**Title & Document Type:** 6942A Multiprogrammer Service Notes

**Manual Part Number:** 06942-90001

## S E R V I C E N O T E

HP MODEL 6942A MULTIPROGRAMMER  
Serial Numbers 2039A - 1050 and below  
FRONT PANEL CHANGE

14711B KIT LAYOUT

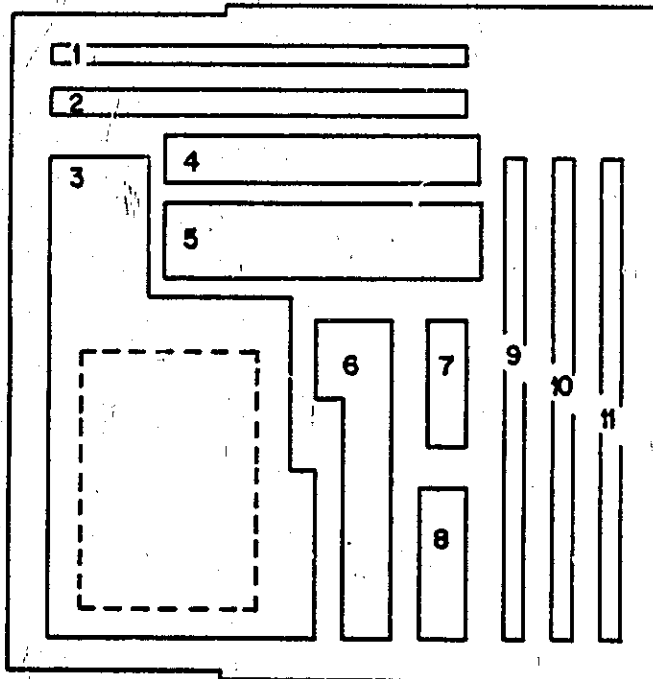
1. Describe the kit layout and circuit assemblies included.
2. List the restored board part number (if applicable).
3. List other recommended component parts that a user may wish to add to the kit.

<u>ITEM</u>	<u>NEW PART NO.</u>	<u>RESTORED PART NO.</u>	<u>DESCRIPTION &amp;</u>
1	06941-60020	-	DST JUMPER BD
2	06942-60024	06942-69024	HP-IB INTERFACE
3	-	-	This space is reserved for a top interconnect bd (06942-60001) which is not supplied with the 14711B.
4	5060-2768	06942-69003	BOTTOM POWER SUPPLY BD (A9)
5	5060-2767	06942-69002	TOP POWER SUPPLY BD (A7)
6	5060-2766	06942-69001	MIDDLE POWER SUPPLY BD (A8)
7	-	-	Space for data cartridges (verification programs).
8	-	-	This space reserved for a FAN, TUBEAXIAL, not supplied in the 14711B.
9	06942-60022	06942-69022	CPU BD (A1)
10	06942-60023	06942-69023	RAM BACKPL CONTROL BD (A2)
11	-	-	For discretionary use. 6943A backplane bd assy fits this slot.

NOTES: 1. A cutout under 3 may be removed to add storage space (a parts box, for example).
